**VENTURA UNIFIED SCHOOL DISTRICT
ELMHURST ELEMENTARY SCHOOL HVAC REPLACEMENT**

ADDENDUM #01

ADDENDUM NUMBER ONE

**E1-24 ELMHURST HVAC**

SH-ET
A-601

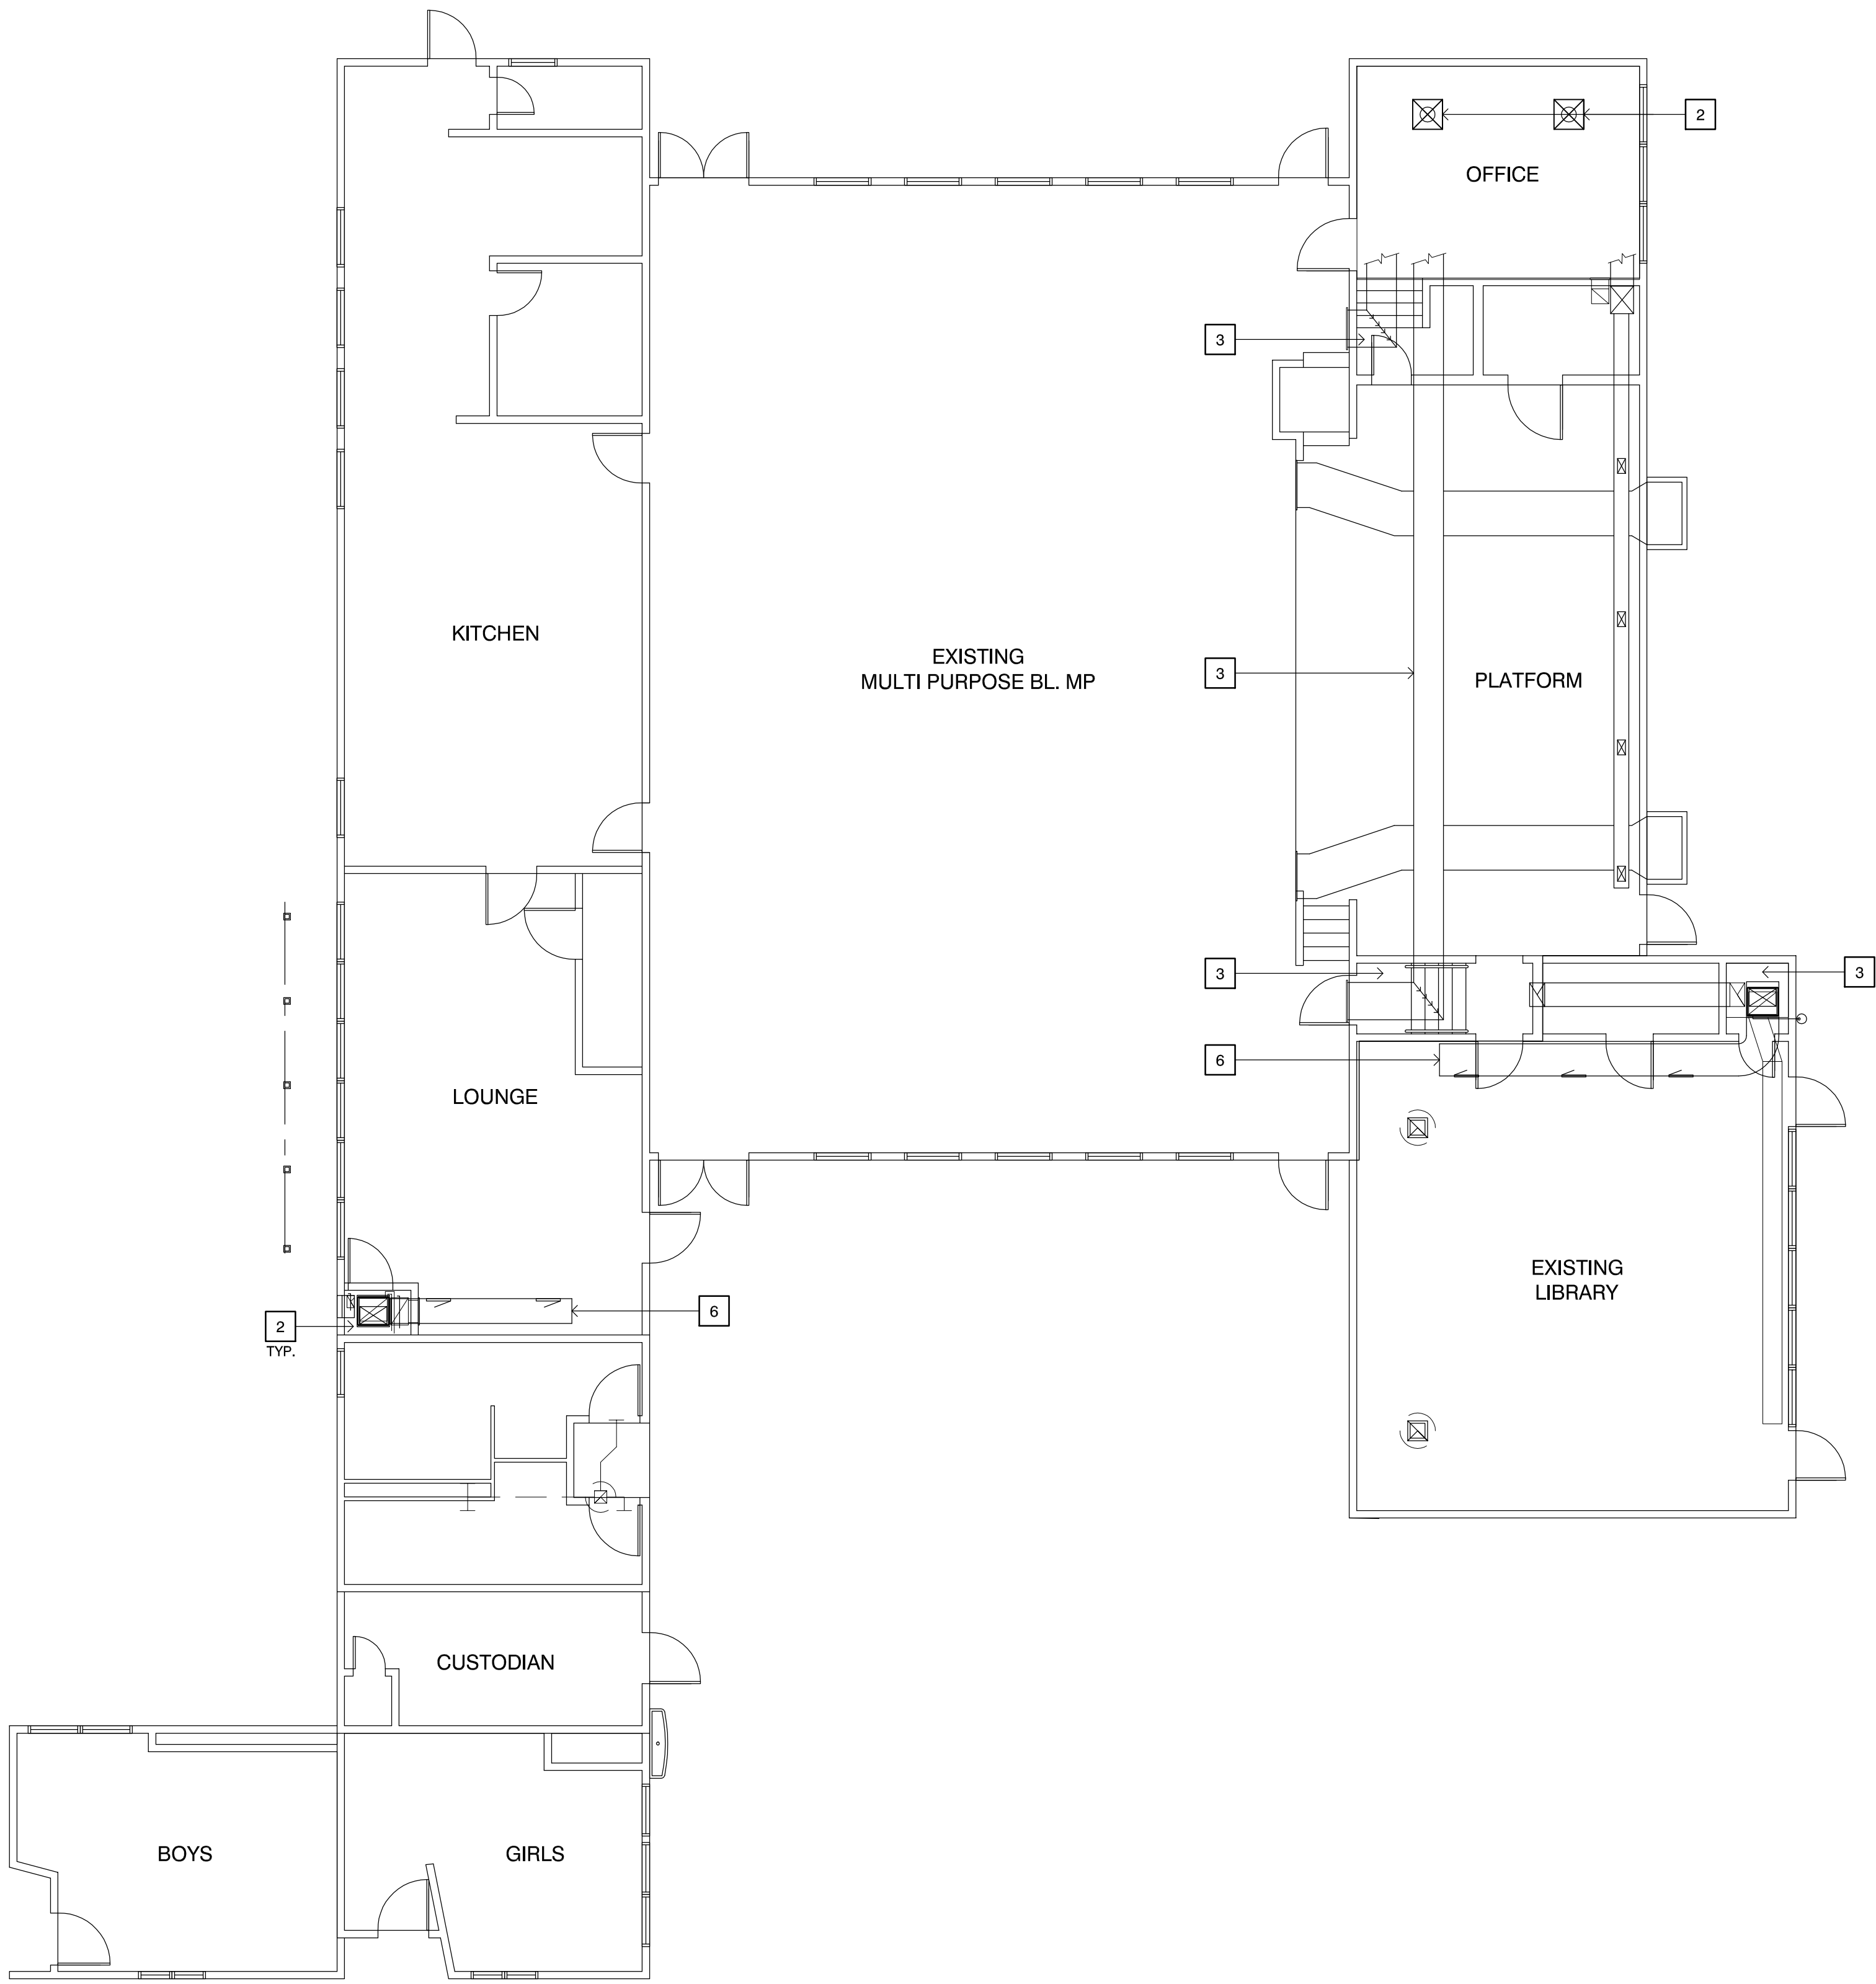
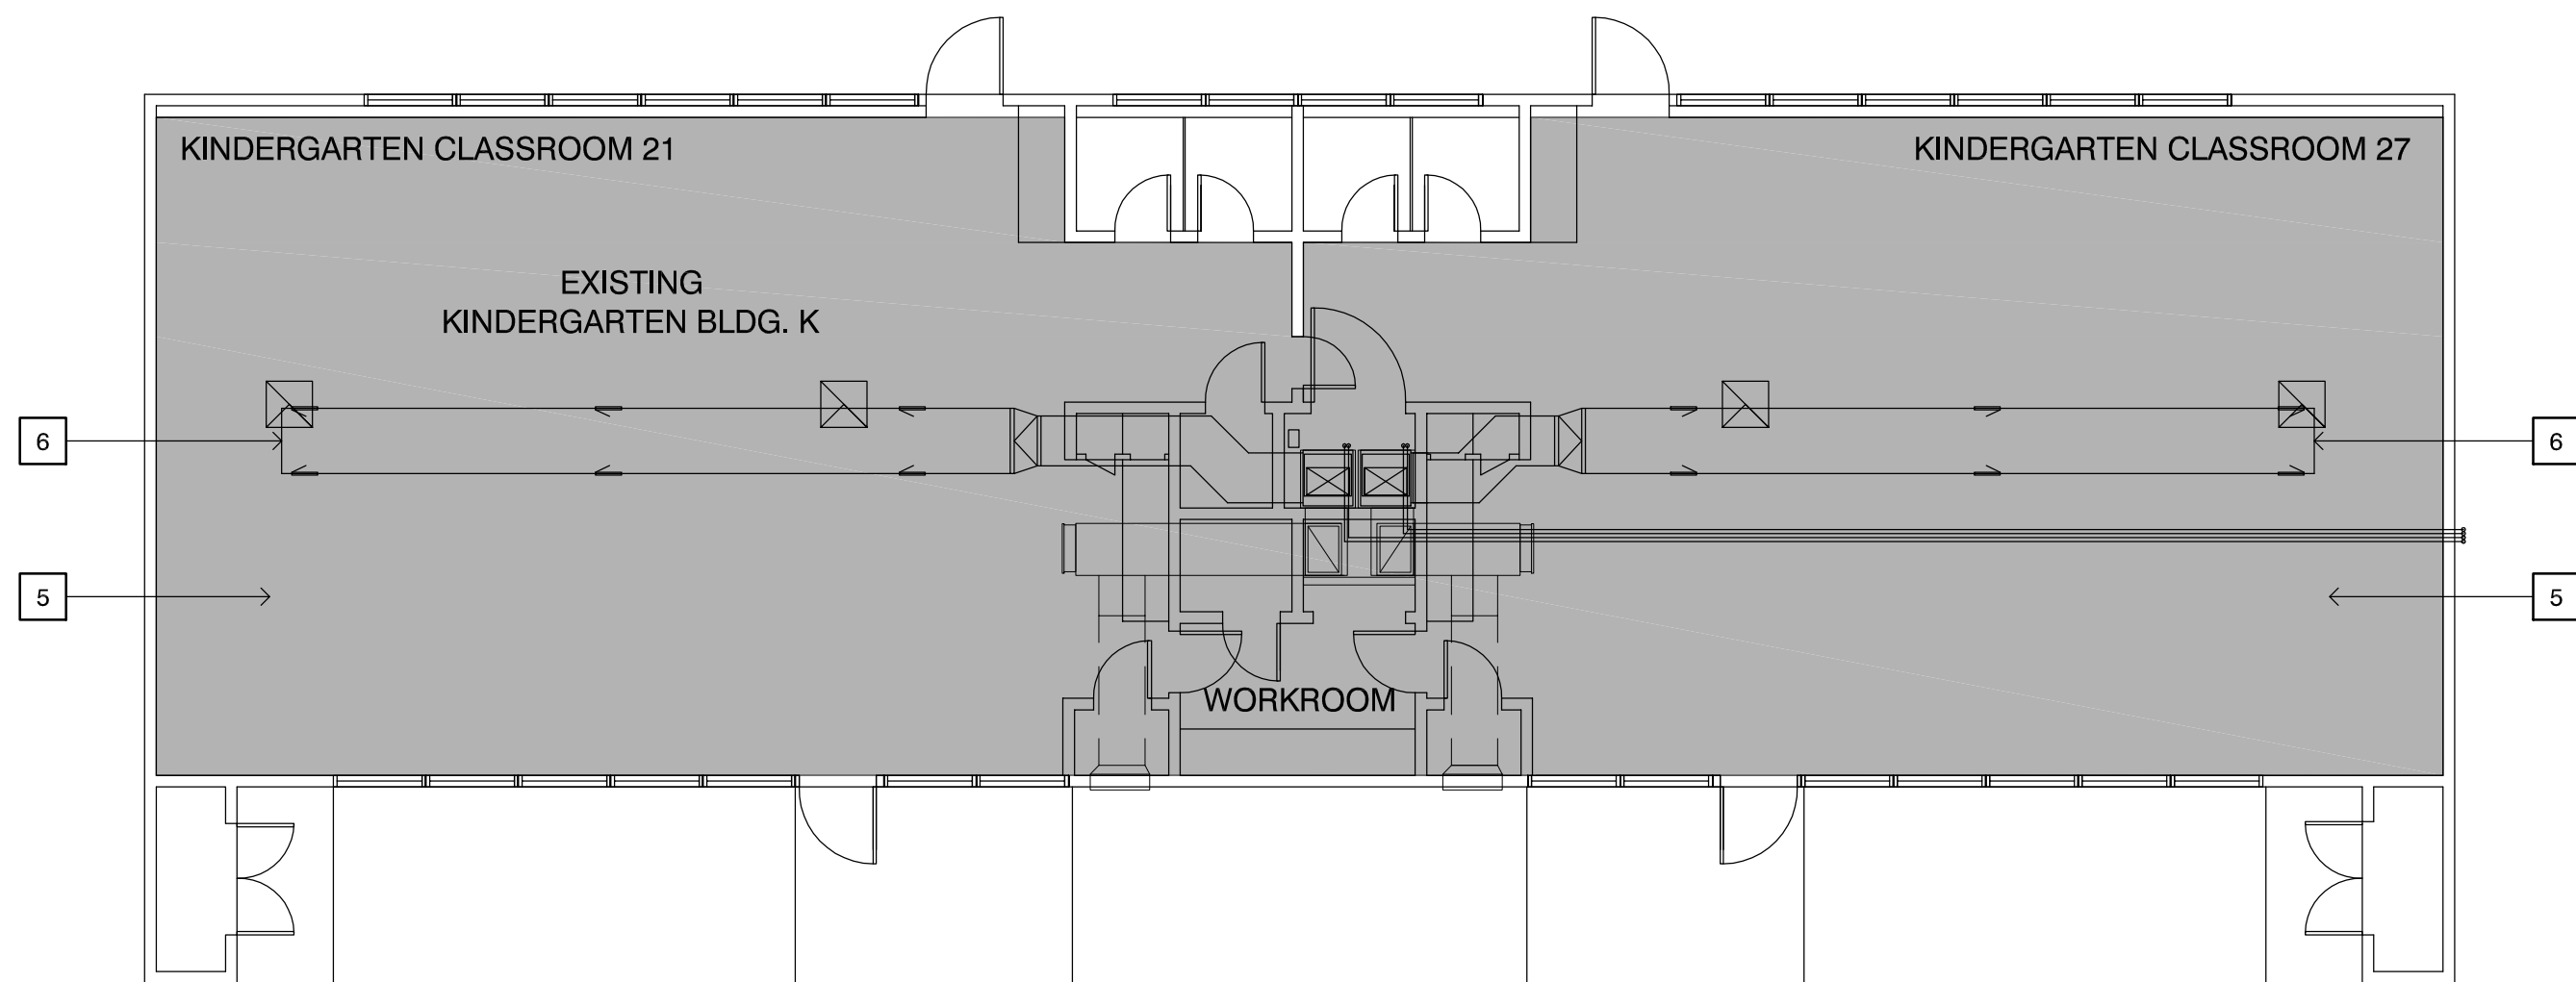
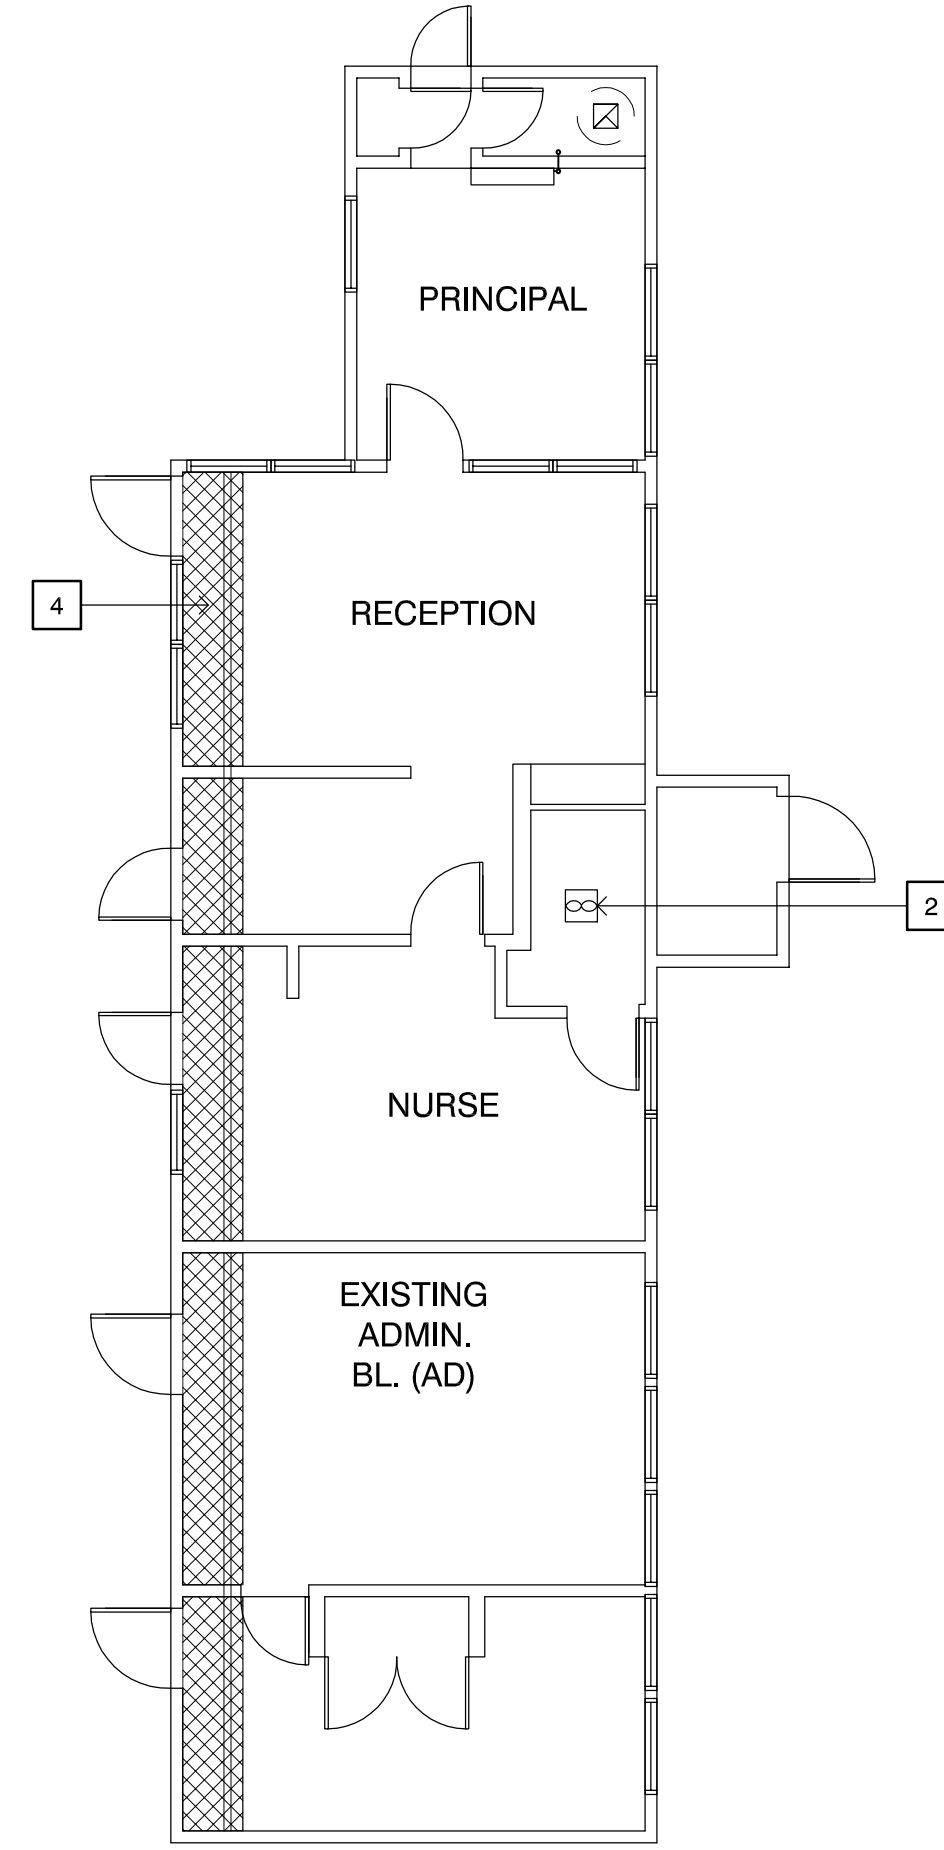
Insert two new drawing sheets A-600 and A-601 to the bid plans. These new reflected ceiling plans indicate extent of planned ceiling modifications and replacements.
